Access Compliance Report

Public Rights-of-Way

(Curb Ramps)

Intersection ID: 27321	Main Street: OWL_NEST_LN	Cross Street: STANETTE_DR	Location: SE
ADA ID: 060EC8308D17	Ramp Type: BlendTrans2	Initial Pass/Fail: Fail	Overall Compliance: No
		Severity Score: 25

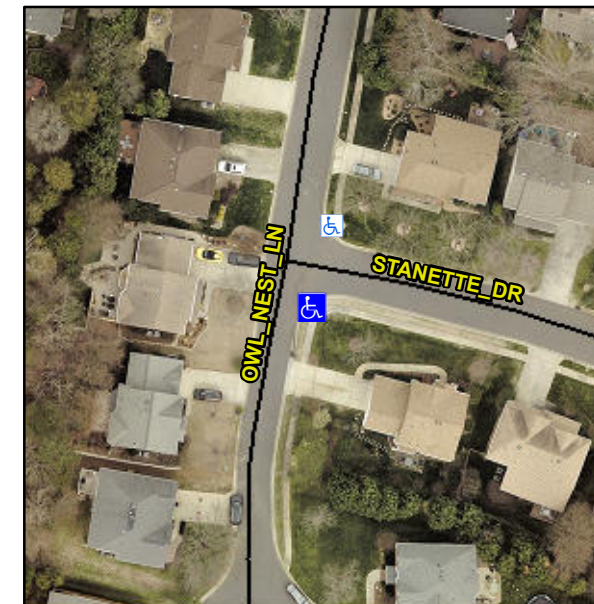
Not Found, R304.5.3

Compliance	Description	Data	Compliance	Description	Data
N/A	Ramp Length (in)	93.5	Yes	BlendTrans Slope (%)	3.9
Yes	Ramp Width (in)	48.0	No	BlendTrans XSlope (%)	10.9
N/A	Flare Type LT	N/A	N/A	Flare Type RT	N/A
N/A	Flare Slope LT (%)	N/A	N/A	Flare Slope RT (%)	N/A
N/A	Flare Traversable LT?	N/A	N/A	Flare Traversable RT?	N/A
N/A	Landing Length (in)	N/A	N/A	DWS Provided?	N/A
N/A	Landing Width (in)	N/A	N/A	DWS Contrast?	N/A
N/A	Landing Slope (%)	N/A	N/A	DWS Length (in)	N/A
N/A	Landing X Slope (%)	N/A	N/A	DWS Full Width?	N/A
N/A	Landing Curb? (Y/N)	N/A	N/A	DWS Offset (in)	N/A
N/A	Shared Landing?	N/A			
N/A	Gutter Ponding?	N/A	N/A	Gutter Slope (%)	N/A
N/A	Gutter Lip Ht (in)	N/A	N/A	Gutter X Slope (%)	N/A
N/A	Painted X Walk1?	No	N/A	Painted X Walk2?	No
	X Walk 1 Direction	To N		X Walk 2 Direction	To W
	X Walk 1 Width (in)	N/A		X Walk 2 Width (in)	N/A
	X Walk 1 Slope (%)	3.4		X Walk 2 Slope (%)	2.1
	X Walk 1 X Slope (%)	2.8		X Walk 2 X Slope (%)	7.9

N/A	Ramp inside XWalk1?	N/A	N/A	Ramp inside XWalk2?	N/A
	Road Slope (%)	7.9		Clear Space?	N/A
	Road X Slope (%)	3.6	N/A	Clear Space to XWalk (in)	N/A
N/A	Any Obstructions?	N/A	N/A	Storm Grate/Utility Hazard?	N/A
	Obstruction Type			Storm Grate/Utility Type	
		N/A			N/A
			Yes	Surface Condition? (G/P)	Good
			No	Curb Slope (%)	10.6

Remove & Replace Curb Ramp With Two New Directional Ramps or Equivalent.
